DEPARTMENT OF NATURAL RESOURCES Division of Oil, Gas & Mining

Inspection Report Minerals Regulatory Program

Mine Name: Asphalt Ridge	Permit number: M/047/022			
Operator or Permittee Name:	Inspecti	on Date: O	ctober 26, 200	4
Uintah County	-			
Permittee Mailing Address:				
1489 E. 335 S., Vernal, UT 84078				
	Weather	: Partly clo	udy, 50's	
Inspector(s): Paul Baker	Inspection Start Time: 10:30 AM			
	Inspecti	on End Tin	ne: 12:30 PM	
Other Participants: Paul Feltch, two other count	ty Site loca	tion/Area I	nspected (i.e.	Pit #):
employees, and Kim McDonald			on of the area	,
Permit Status: Active	Surface Ownership: SITLA and Fee			
Current Acreages:	Mineral	Ownership	: Fee	
Total Permitted (Bonded): 44	Mineral	Mined: Tai	r Sand	
Total Disturbed: 44	Type of	Mine: Surfa	ace	
Elements of Inspection	Evaluated	N/A	Comment	Enforcement

M/037/022, Asphalt Ridge Mine, Uintah County

Photo 1. The circled area contains material that was apparently graded down from areas closer to the foreground.

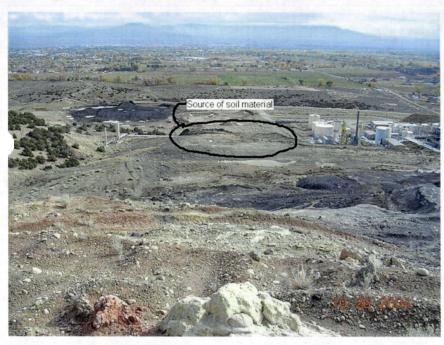
Most of our discussion focused on backfilling and grading. The primary concern was regrading of the area shown across the middle of Photo 2. The area should be smoothed to a more natural contour, but rock outcrops do not need to be graded. The surface should then be ripped prior to applying soil. Soil would be brought in scrapers from the area circled in Photo 1 and applied at a thickness of about one foot.
